**TEXAS UTILITIES GENERATING COMPANY**

SUBJECT: COMANCHE PEAK STEAM ELECTRIC STATION  
DOCKET NOS. 50-445 and 50-446  
RESPONSE TO QUESTIONS ON HEATUP AND COOLDOWN  
CURVES FOR USE IN THE TECHNICAL SPECIFICATIONS

RESPONSE TO NRC QUESTIONS  
121.15 AND 121.16

FRACTURE AND NDE EVALUATIONS FOR  
THE CLOSURE FLANGE REGIONS OF  
COMANCHE PEAK UNITS 1 AND 2

**Figure 4** IMPACT OF NEW 10CFR50 RULE (WITHOUT SPECIAL STRESS ANALYSIS) ON  
COMANCHE PEAK UNITS 1 AND 2 REACTOR COOLANT SYSTEM HEATUP LIMITA-  
TIONS APPLICABLE UP TO 16 EFPY

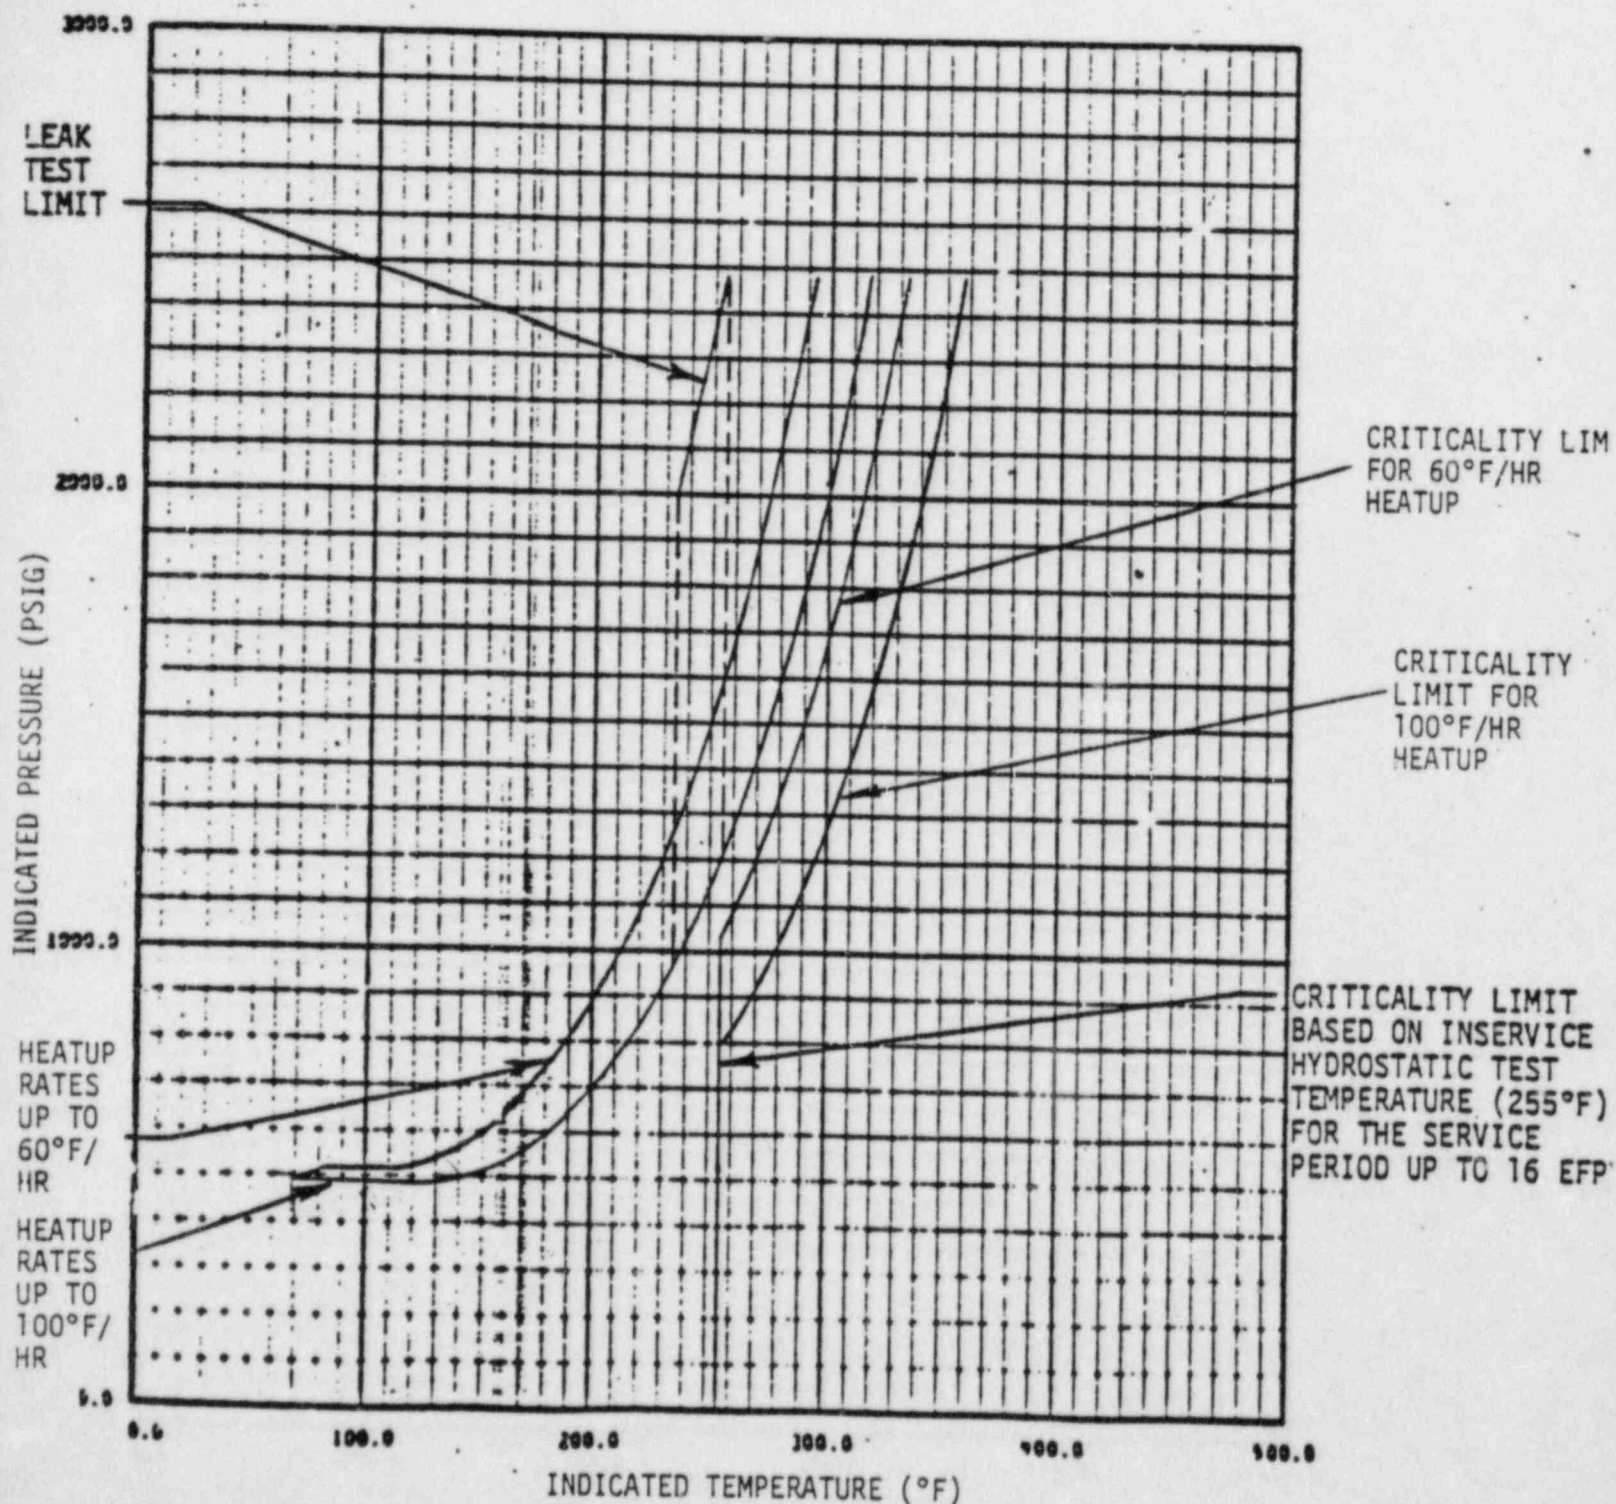
The pressure stresses used in the analysis are based on an internal pressure of 776 psig since this is the maximum allowable pressure on Figures 4 and 5 in the temperature range from 120°F to 160°F.

Figure 6 COMANCHE PEAK UNITS 1 AND 2 REACTOR COOLANT SYSTEM HEATUP LIMITATIONS APPLICABLE UP TO 16 EFPY

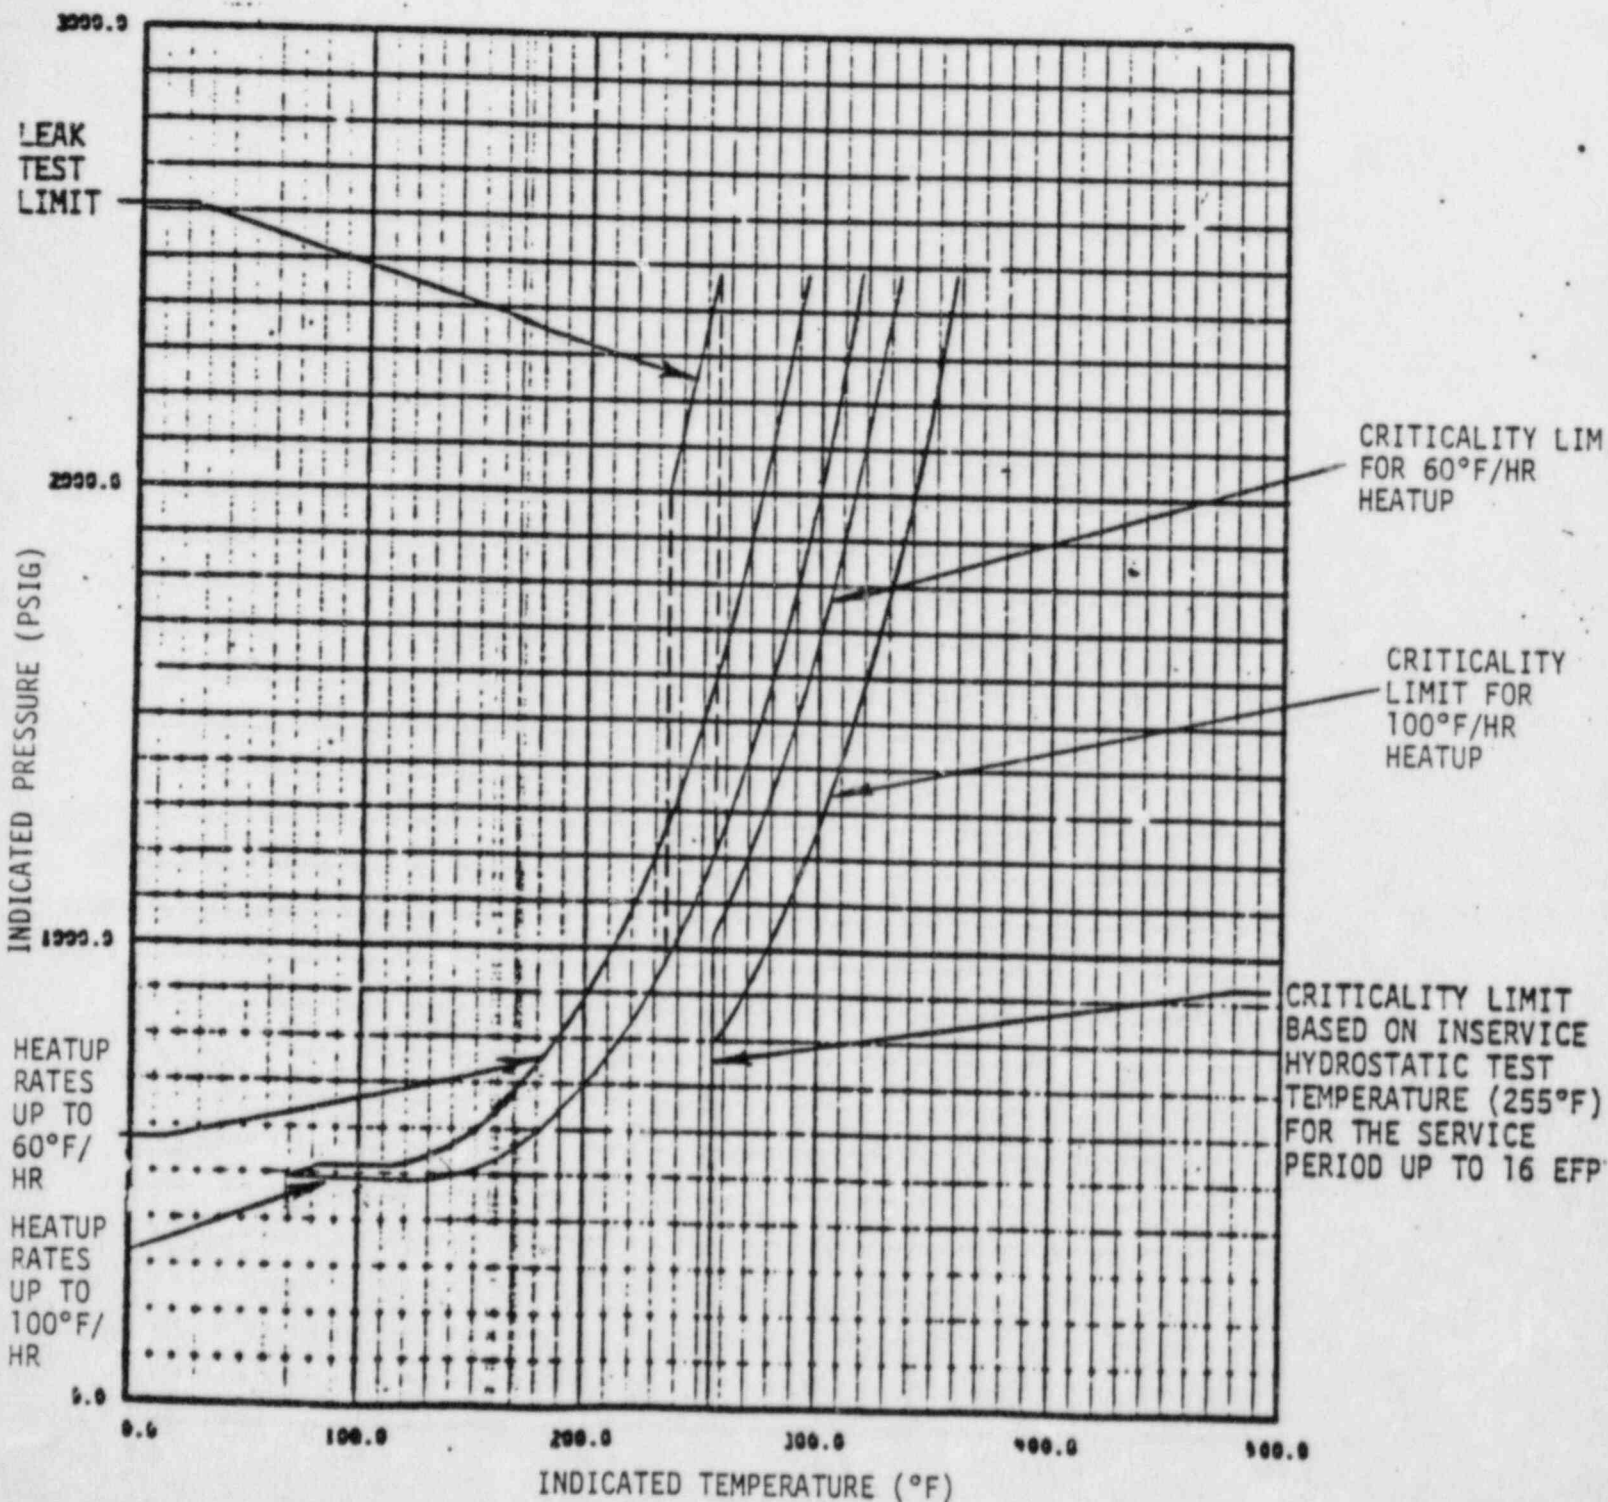
Enclosed are our responses to the questions transmitted to us by your letter dated December 9, 1983. It is requested that Figures 6 and 7 of the enclosure be included as Figures 3.4-2 and 3.4-3 of the Comanche Peak Technical Specifications.

This section describes the pressure-temperature limit that will be used to pressurize the reactor vessel from 400 psig to the leak test or hydrotest pressure. To reach the test pressure, follow the normal heatup curve in Figure 6 up to the minimum temperature required for the test. Then follow a vertical line (dashed in Figure 6) up to the desired test pressure.

FIGURE 9: HEAD-TO-FLANGE WELD JOINT

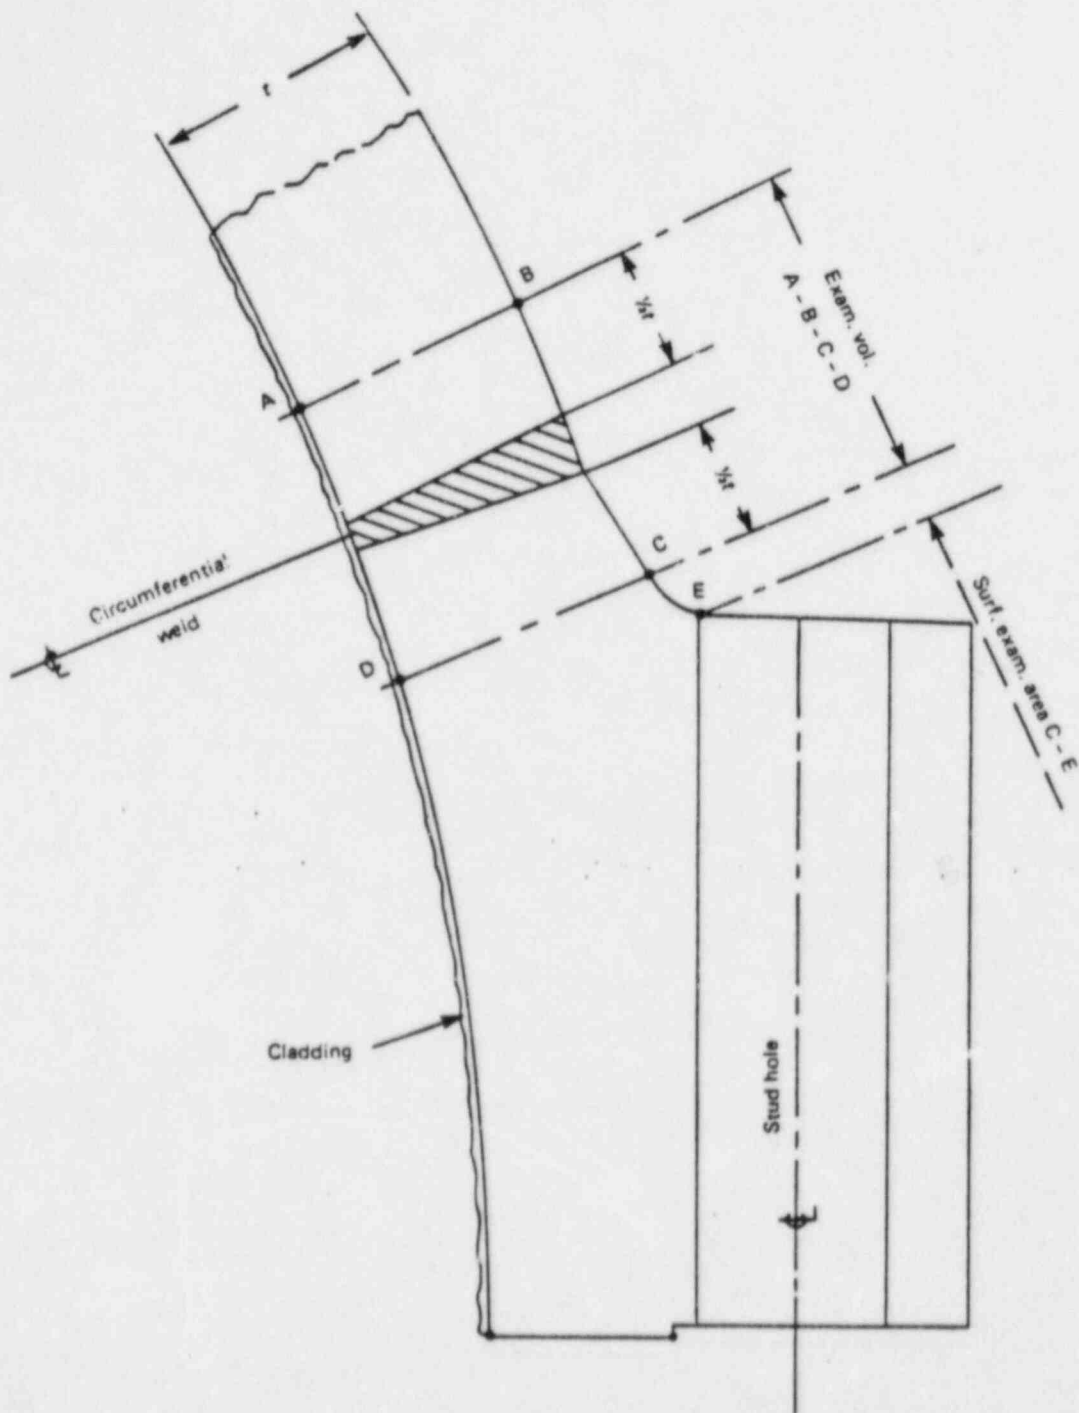
Nondestructive examinations currently specified for inservice inspection of the reactor vessel flange-to-upper shell weld and the vessel head flange-to-dome weld are in accordance with Section XI of the ASME Boiler and Pressure Vessel Code [6]. Table IWB-2500-1 requires volumetric examination of flange-to-shell welds and volumetric and surface examinations of head flange-to-dome welds. The 1980 Edition of Section XI specifies the boundaries for volumetric examination include the weld and adjacent base material for a distance equal to one-half the weld thickness on both sides of the weld, Figures 8 and 9. The area specified for surface examination is the radiused or transition section of the flange on the outside surface as shown in Figure 9 between locations C and E.

Volumetric examination of the reactor vessel closure head flange-to-dome weld and specified adjacent base material is accomplished by  $0^{\circ}$ ,  $45^{\circ}$  and  $60^{\circ}$  refracted angle coverage from the head outside surface. Angle beam scanning is performed in two directions parallel to the weld and perpendicular to the weld from the dome side. Surface examinations of the radiused or transition section of the head flange outside surface are conducted by a magnetic particle technique.
